Release Notes for DrayTek Vigor2862 series (UK/Ireland)

Firmware Version	3.8.9.1_BT (Formal Release)
Release Type	Regular – Upgrade recommended when convenient Note: A previous firmware (3.8.8.2_BT) was a critical release . This f/w includes all changes/improvements that were in 3.8.8.2_BT.
Build Date	12 th June 2018
Release Date	19 th June 2018
Revision	74522
Applicable Models	Vigor2862, Vigor2862n, Vigor 2862Ln, Vigor2862ac, Vigor 2862Lac, Vigor 2862Vac
VDSL Modem Code	779517
ADSL Modem Code	773F01
Locale	UK & Ireland Only

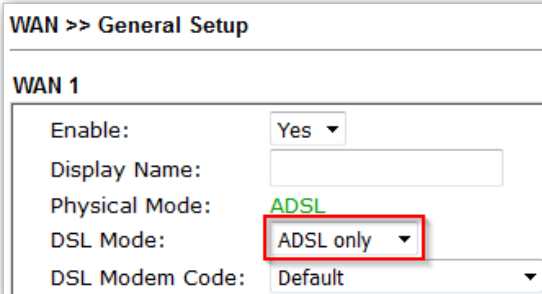
1. If experiencing an issue establishing an Internet connection on ADSL or ADSL2+ connections, set the WAN1 DSL Mode to “ADSL Only”
